### APPEAL SUMMARY

<b>Appeal ID:</b> 14719	<b>Project Address:</b> 6204 NE 8th Ave (South Lot 2)
<b>Hearing Date:</b> 3/8/17	<b>Appellant Name:</b> Roseann Johnson
<b>Case No.:</b> P-002	<b>Appellant Phone:</b> 971-221-6734
<b>Appeal Type:</b> Plumbing	<b>Plans Examiner/Inspector:</b> LUR Planner: Sean Williams; BES LUR: Ben Kersens; FP: Unknown
<b>Project Type:</b> residential	<b>Stories:</b> 2 <b>Occupancy:</b> Residential Housing <b>Construction Type:</b> Residential
<b>Building/Business Name:</b>	<b>Fire Sprinklers:</b> Yes - Lot 2 & 3 Homes to be determined at final plat
<b>Appeal Involves:</b> other: Shared Drywell for Stormwater Management	<b>LUR or Permit Application No.:</b> 16-182762 LDS
<b>Plan Submitted Option:</b> pdf [File 1] [File 2] [File 3] [File 4]	<b>Proposed use:</b> Shared drywells for Lots 2&3 with attached homes

#### Appeal item 1

## APPEAL DECISION

## PROPOSED CONDITIONS

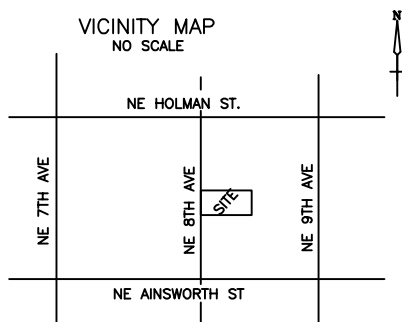
<b>Requires</b>	Section 308.1 Except as otherwise provided in this code, no plumbing system, drainage system, building sewer, private sewage disposal system, or parts thereof shall be located in any lot other than the lot that is the site of the building, structure, or premises served by such facilities. The stormwater management facility for each lot shall be entirely independent.
<b>Proposed Design</b>	The subject site is currently under consideration for a three-lot land division with a private tract 'A' private street. One shared dry well is proposed to serve Lots 2 and 3. (An individual dry well is proposed to serve Lot 1, and an individual dry well is proposed to serve the private tract 'A' street; private street SD permit 123240). The shared dry well for lots 2 and 3 is proposed to be located within a reciprocal 10 foot X 10 foot easement. The dry well itself will be located a minimum of 10 feet from the building structure and 5 feet from any property line as measured to the center of the facility. Connections between each unit of each structure and the associated dry well will not cross property lines.

<b>Reason for alternative</b>	Lots 2 and 3 will be developed with an attached homes structure consisting of two units sharing a common wall. These units will function as individual dwelling units. Given the relatively narrow widths of the proposed lots 2 and 3, shared dry wells will allow for increased Title 11 tree density, feasible front yard tree planting required by community design standards (33.218.100), as well as private street trees to be planted within 5' of the street tract, required by the administrative rule for private rights-of-way. Due to the smaller size of the proposed lots, the common wall construction of the two-unit attached structure, and the tree requirements, a shared dry well in the

front of lots 2 and 3 seems most practical. The dry well will only pick up roof runoff and will meet sizing requirements based on roof area of the two-unit attached structure. At a 6/12 roof pitch, the total roof area of the attached structure is proposed to be approximately 2,110 square feet, certainly within the capacity for a 4 foot X 5 foot dry well.

**Shared Drywell: Granted provided an Operations and Maintenance agreement and easement are recorded.**

**Maintenance agreement and easement must be reviewed and approved by Bureau of Development Services prior to recording. Appellant shall contact Sean Williams (503-823-7612) for information.**
